TO: COMMENT DUE DATE: 22-OCT-1990
FROM: SUBDIVISION REVIEW AND DESIGN
OFFICE OF LAND DEVELOPMENT SERVICES
SUBJECT: FINAL SUBD. REQUIRING PRELIM. REVIEW C8-90-0040.1A
RE: BREAKAWAY PARK SECTION 3

THE FOLLOWING COMMENTS MUST BE ADDRESSED PRIOR TO RECEIVING PLAN APPROVAL FROM THE DEPARTMENT OF PLANNING AND DEVELOPMENT. IT IS THE RESPONSIBILITY OF THE APPLICANT OR HIS/HER AGENT TO MODIFY THE SUBDIVISION PLAN SO THAT IT COMPLIES WITH THESE REQUIREMENTS.

EXHIBIT "A"

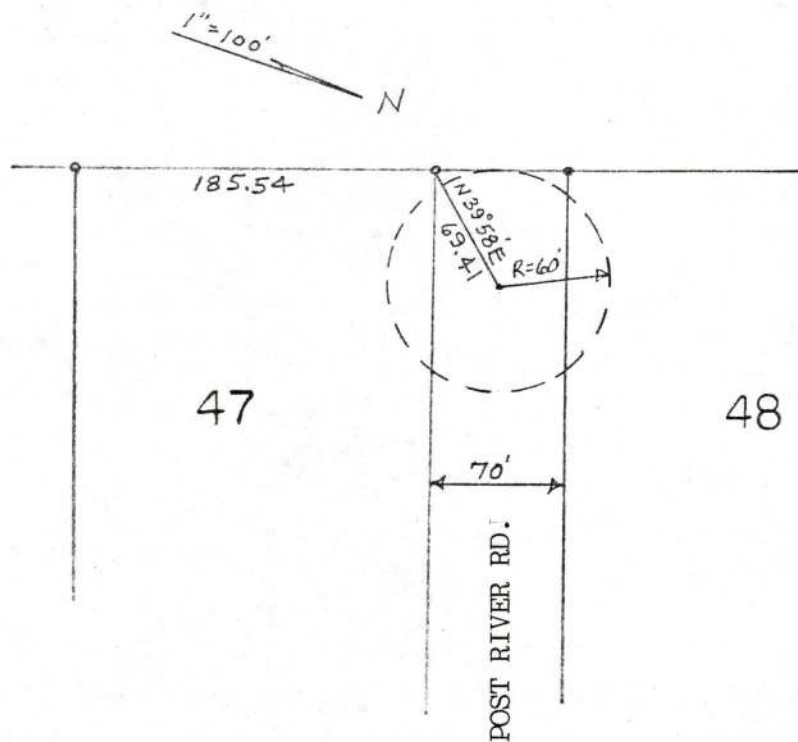
TR 2. The cul-de-sac for Chitina Court must be designed in accordance with the approved preliminary plan and the standards in the City of Austin Transportation Criteria Manual. Show a 60 foot right-of-way radius for the Chitina Court cul-de-sac in accordance with the preliminary plan. (C8-90-0040)

This easement is a full circle with a radius of 60 feet.
The radius point is located N39°58'E 69.41 feet from the northwest corner
of Lot 47, Breakaway Park Section 3, Williamson County, Texas.
